█ comments re Ashbourne development (Property adjacent to the Proposed Northern Solar farm)

I do not believe that this project conforms to the criteria for the Fast-track process. This Fast-track proposal could have large negative impacts which would outweigh the positive impacts for Matamata or New Zealand (regional or national benefits).

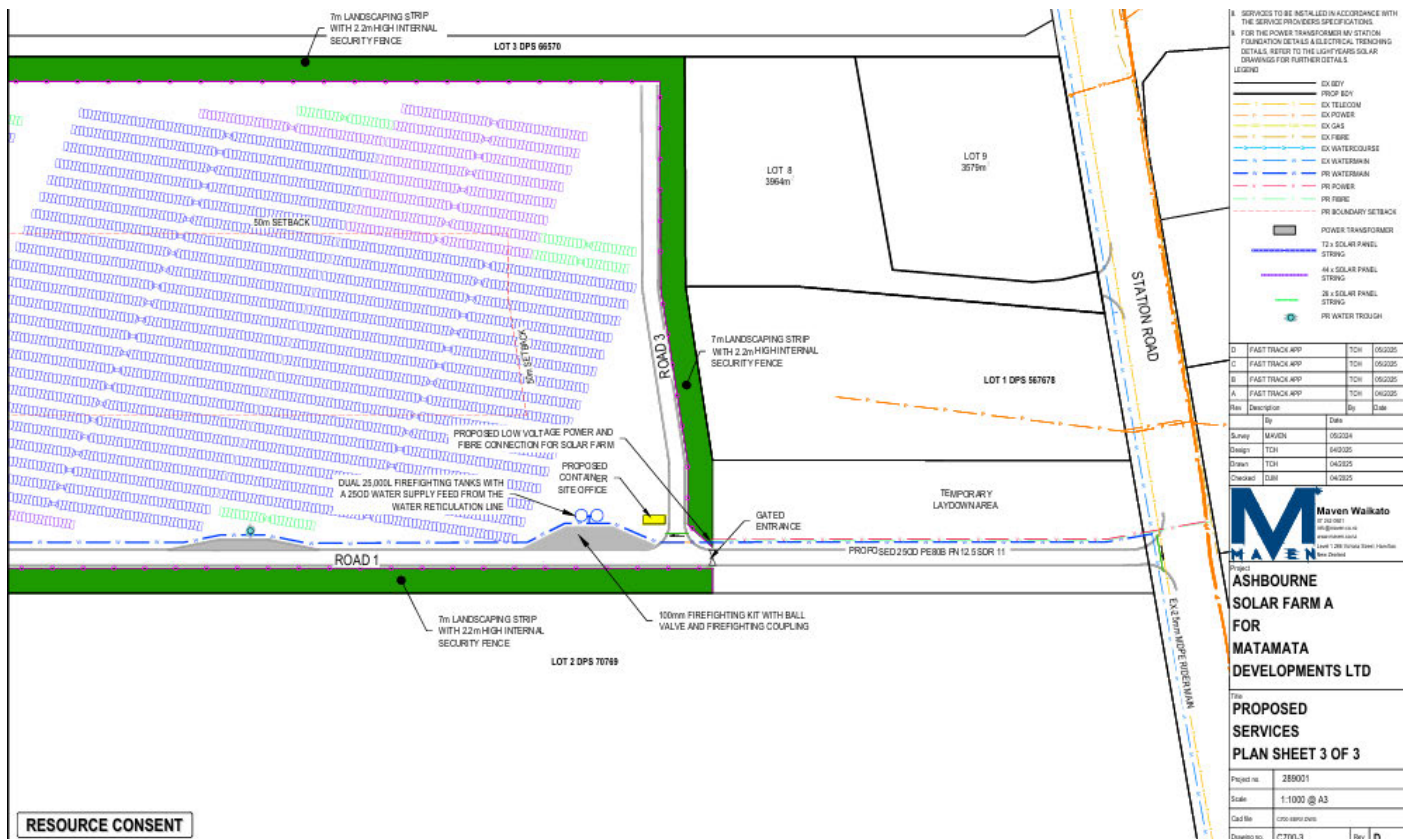
The below diagrams show that the developers are proposing to join up with the existing Matamata water supply. I do not see how this is possible. Properties closer to town that have recently built have been declined access to this water supply pipe and have had to provide their own water (either bore or roof supply). The property at [REDACTED] is an example of this. How are they going to provide water to this farm when other houses closer to town are unable to?

Is the council aware that this is for stock management as well as the needed firefighting water tanks?

SPECIMEN TREES

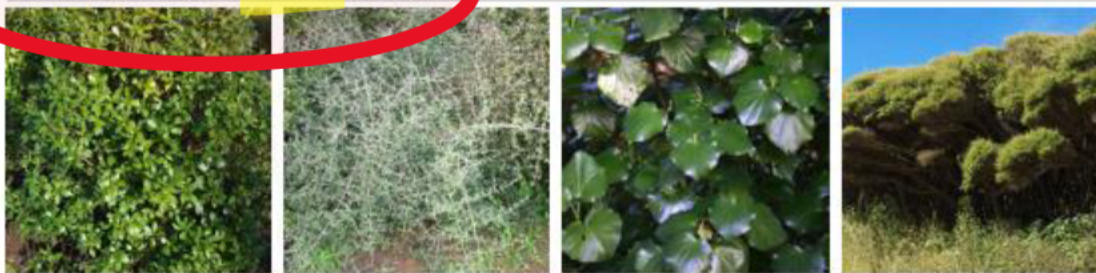
In the later plan https://www.fasttrack.govt.nz/_data/assets/pdf_file/0015/10149/Appendix-3B_Landscape-Drawings_02_of_03.pdf they state 5m **minimum** height in one diagram and 5 mtrs **maximum** height in other places of the same document . This will have a huge impact on me if the correct answer is minimum.

I was sent an email from the developers after questioning them about the buffer, with a picture of the above vegetation buffer. This email was incorrect/ deficient. It did not show the huge trees that they have included in another document that are planned to be planted directly north of my property (kahikatea trees that grow to 65 metres along with 3 other species). I had to find this information myself on the fast-track website. These very large trees will shade my property, possibly causing mould and mildew to grow. I have solar panels on my roof. These trees could shade these panels and negate my own solar energy, which is being exported into the national grid.

Inconsistencies in placement of transformers

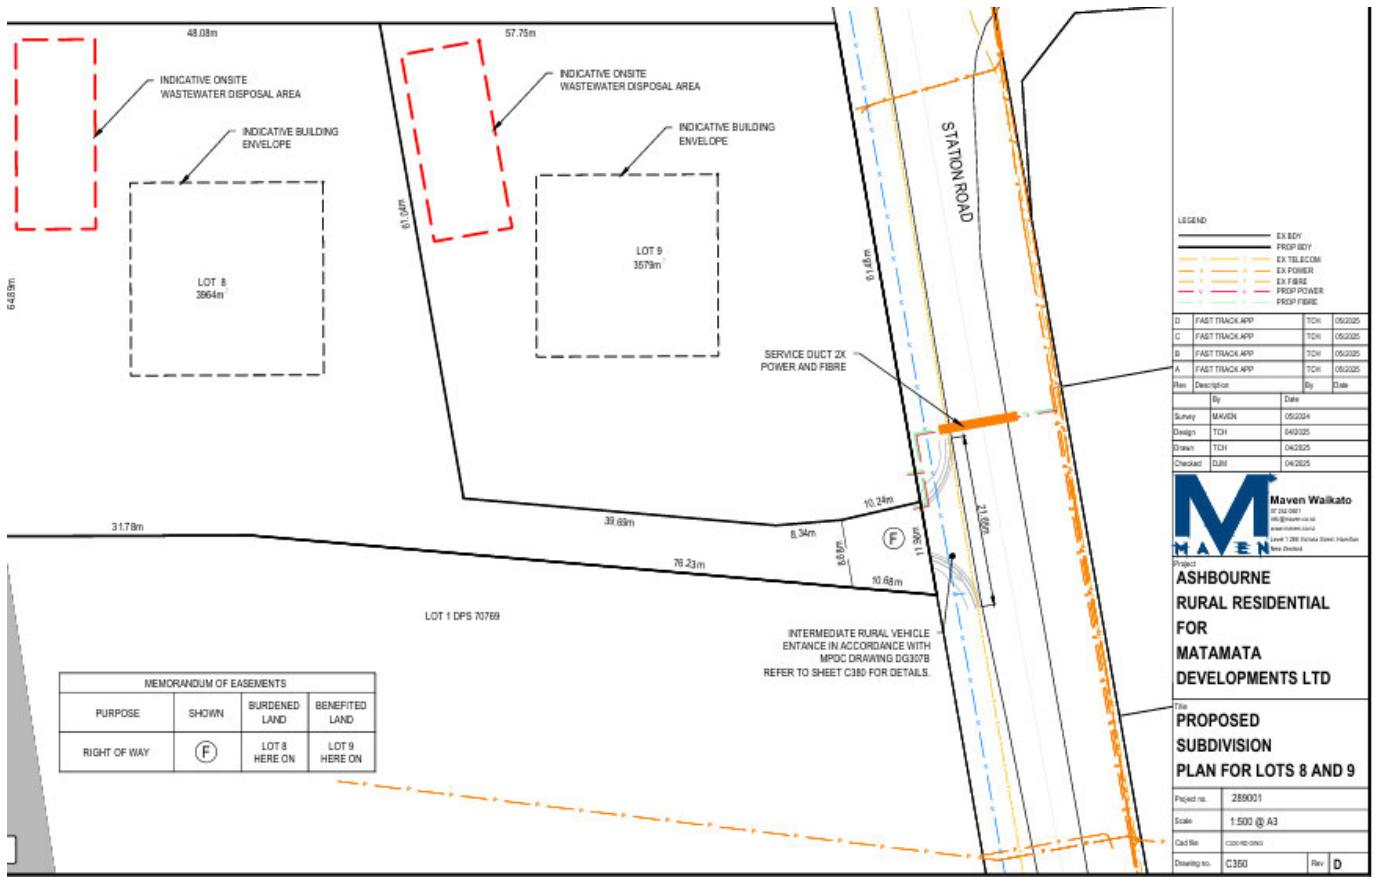
There are also 2 different plans for the Northern solar farm in different documents in the substantive application. One says the transformers are placed at 1/3 and 2/3rds within the solar farm. (App.3F Engineering Drawings Northern p.1 and p.10). Another shows one transformer very close do my section boundary (with the other halfway down) (1M Geotechnical report part 1 p.30). I have since been told that the correct is 1/3 -2/3 placement, but I am very concerned that both were in the substantive plans when one could have been shown as no longer applicable. I also have concerns as to whether this is actually correct.

Title
PROPOSED SUBDIVISION PLAN FOR LOTS 8 AND 9

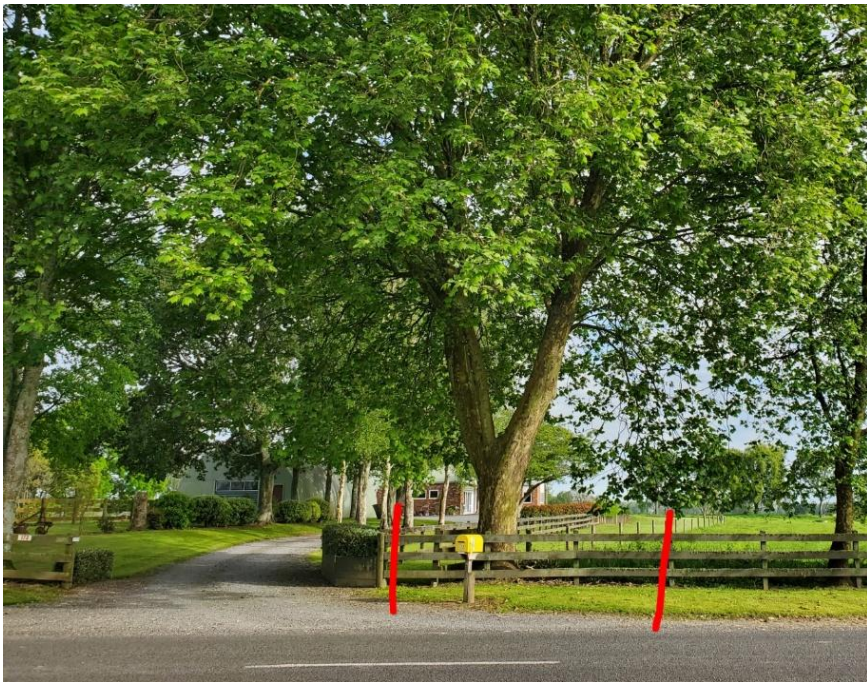
The above photos are of the tree which is on the border of 172 Station and the entrance way to proposed Lot 8 which has very large roots extending in all directions. Also note another tree to the right.
